## Access Compliance Report Public Rights-of-Way (Curb Ramps)

Intersection ID: 27584 Main Street: ELM\_LN Cross Street: WILLIAMS\_POND\_LN Location: SW

ADA ID: 5B886361FEBD Ramp Type: Perp Initial Pass/Fail: Fail Overall Compliance: No Severity Score: 13.75

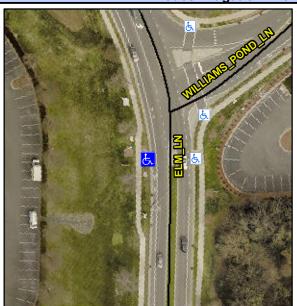
Possible Solutions:	<u>c</u>		
Remove & Replace Entire Ramp.			
	Y		
	N		
	N		
	N		
	N		
Surveyor Notes:	N		
N/A	N.		
	N		
	N.		
	N		
PROW/ADA:	N		
Not Found, R304.2.2, R304.5.3	N		
, ,	N		
	N		
	N

Field Measurements/Component Compliance						
Compl	iance Description	Data	Comp	liance Description	Data	
N/A	Ramp Length (in)	103.0	No	Ramp Slope (%)	8.5	
Yes	Ramp Width (in)	48.0	No	Ramp XSlope (%)	2.4	
N/A	Flare Type LT	N/A	N/A	Flare Type RT	N/A	
N/A	Flare Slope LT (%)	N/A	N/A	Flare Slope RT (%)	N/A	
N/A	Flare Traversable LT?	N/A	N/A	Flare Traversable RT?	N/A	
N/A	Landing Length (in)	N/A	N/A	DWS Provided?	N/A	
N/A	Landing Width (in)	N/A	N/A	DWS Contrast?	N/A	
N/A	Landing Slope (%)	N/A	N/A	DWS Length (in)	N/A	
N/A	Landing X Slope (%)	N/A	N/A	DWS Full Width?	N/A	
N/A	Landing Curb? (Y/N)	N/A	N/A	DWS Offset (in)	N/A	
N/A	Shared Landing?	N/A				
N/A	Gutter Ponding?	N/A	N/A	Gutter Slope (%)	N/A	
N/A	Gutter Lip Ht (in)	N/A	N/A	Gutter X Slope (%)	N/A	
N/A	Painted X Walk1?	No	N/A	Painted X Walk2?	N/A	
	X Walk 1 Direction	To E		X Walk 2 Direction	N/A	
N/A	X Walk 1 Width (in)	N/A	N/A	X Walk 2 Width (in)	N/A	
	X Walk 1 Slope (%)	3.6		X Walk 2 Slope (%)	N/A
